Re: Coastal Development Permit Application 5-13-032 ("Application")
Newport Banning Ranch ("Project")

The purpose of this letter is to respond to the June 5, 2014 Notice of Incomplete Application. The NBR team is hopeful that with the meetings that have occurred with Coastal Planning Staff, subsequent follow-up correspondence and this response fully address all of CCC Staff's requests for information and additional data.

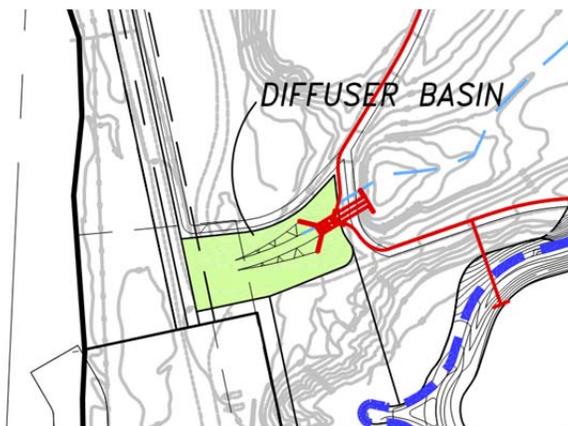
The 30% grading plan that was submitted May 6, 2014 indicates that 2 water quality features will require development through and under the "consolidated oil production site (consolidation area). The pipes leading from the northern subdivision to the large water quality basin located in the lowlands are shown going through the consolidation site. As submitted, it is unclear how the storm water from the Southern Arroyo exits the arroyo and enters the Semeniuk slough. Does it sheet flow over the top of the road and into the slough (which is not appropriate for water quality)? If not, a pipe or culvert under the road of the consolidation area is necessary. These are examples of development occurring in the oil consolidation area (not covered by an exemption) and do require a CDP. Because both of these examples are related to the current CDP application, we continue to require additional information regarding proposed development in the consolidation area.

The project's design intent is to preserve the existing discharge point connection between the downstream end of the Southern Arroyo and the upstream end of the Semeniuk Slough. Under existing conditions, flows pond up at the downstream end due to the physical presence of an oil access road that is located between the terminus of the Southern Arroyo and the Semeniuk Slough. Flows pond up approximately 3-4 feet before spilling over the road and continuing to sheet flow over vegetated areas and an additional access road before draining into the Semeniuk Slough.

Under the proposed Project, flows will continue to drain and collect in a sump area due to the existing roadway. As part of the proposed Project improvements, storm drain flows from the southern and northern development areas will be collected in storm drain pipes and will connect into a proposed diffuser basin / energy dissipater (water quality basin) located within and under existing roadway. The structure will be designed to accept piped in flows and upstream flows from the Southern Arroyo and then transition the flows in a non-erosive manner to the downstream segment before sheet flowing into the Semeniuk Slough. Energy dissipation measures will be included downstream of the existing access road (shown in the green area in the image below) to reduce the flow

Typical Biotreatment Cross Section & Detail:

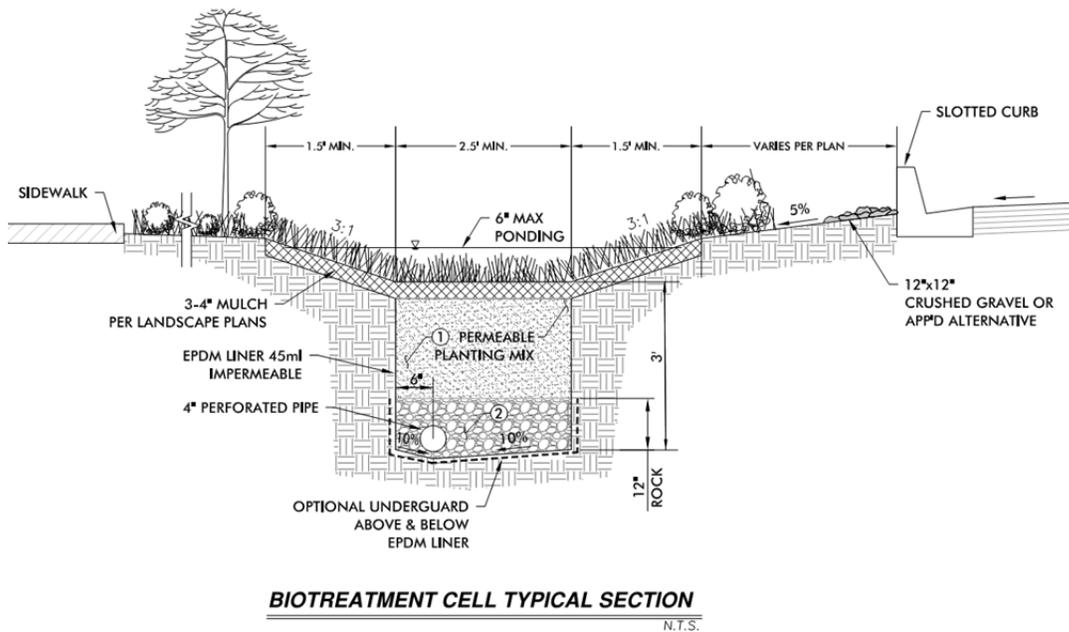
- B. *Community Basins. There are 15 detention/infiltration water quality treatment basins labeled "community basins" in Exhibit 9-2. Please provide the specifics regarding these basins such as: size and capacity, drainage paths in/out, and construction specifications. Please specify the originating location of runoff that*

they are designed to treat. Many of these community basins are located in the parkway areas along the bluff top, between the housing development and the bluff edges. Given their proximity to the bluff edge, how will these be designed to prevent bluff instability and erosion? Some of the community basins are depicted within individual parcels, possibly in individual homeowners' backyards and front yards. Please clarify the details of these basins and provide updated maps to indicate where these will be placed, and provide details regarding how they will be maintained if on individual parcels.

In total, there are approximately 23 Community Basins proposed to provide treatment of all development runoff prior to discharging into the lowlands. See Exhibit 9 for a depiction of all the proposed Community Basins. The location of the basins took into account the proximity of the bluff edges. Due to the significant constraints to infiltration previously documented, all community water quality basins will be designed as flow-through biofiltration basins with impermeable liners to prevent infiltration and incidental seepage. With the inclusion of the impermeable liners, concerns about bluff instability and erosion will be minimized. The table below summarizes the tributary areas associated with each storm drain line, the water quality basin ID's associated with each tributary area, the treatment required, the footprint and the ponding depth. A total treatment summary is also provided.

In addition, a typical cross section and typical specifications are provided for additional details on the proposed community water quality basins.

- ① 24" PLANTING MEDIA THAT IS SUFFICIENTLY PERMEABLE TO ACHIEVE A LONG TERM, IN-PLACE FILTRATION RATE OF AT LEAST 5 INCHES PER HOUR AND SUPPORT VIGOROUS PLANT GROWTH. PLANTING MEDIA SHALL CONSIST OF THE FOLLOWING MIXTURE OF FINE SAND AND COMPOST, MEASURED ON A VOLUME BASIS: 70%-80% SAND, AND 20%-30% COMPOST. SEE LANDSCAPE PLANS FOR ADDITIONAL DETAILS ON SOIL/PLANTING MIX.
